Status: Y N U **Seismic Walkdown Checklist (SWC) SWEL1- 045**Equipment ID No. SZ51B002A Equip. Class¹ 9 - FansEquipment Description Supply Fan (Control Room A/C Unit Fan)Location: Bldg. CB Floor El. 133 Room, Area OC302, CBManufacturer, Model, Etc. (optional but recommended) Buffalo Forge Co., 730-BLD**Instructions for Completing Checklist**

Seismic Walkdown Checklist (SWC) SWEL1- 045

Equipment Description Supply Fan (Control Room A/C Unit Fan)

Note: Anchor bolt slightly tilted

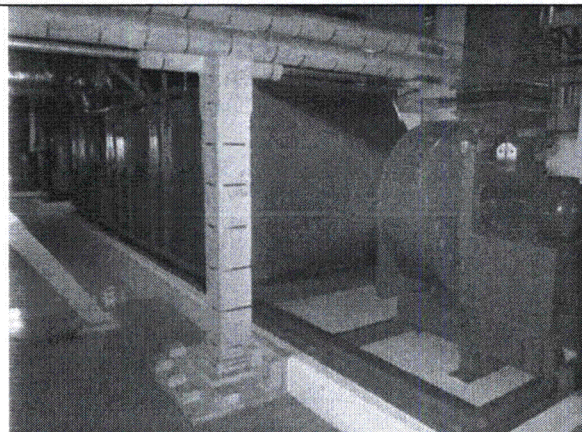
2. Is the anchorage free of bent, broken, missing or loose hardware? Y N U N/A
*Fan skid is mounted to the concrete pedestal with (24) 3/8" dia. anchor bolts.
 Few anchor bolts are on a slight angle; however, this doesn't pose a seismic concern. See photo.*

Note: *Pedestal, non-Structural Crack/Chip*

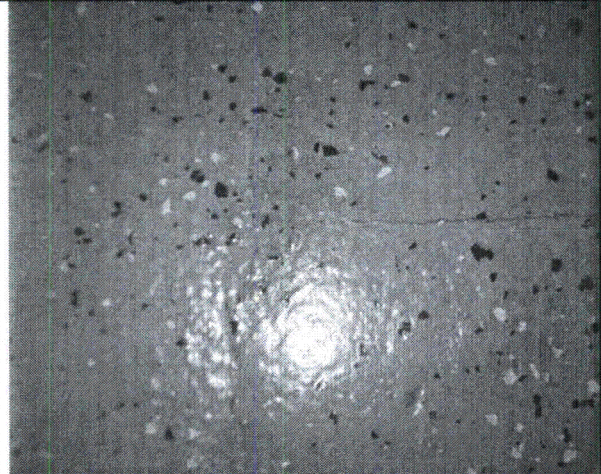
Note: *Surface Cracks*
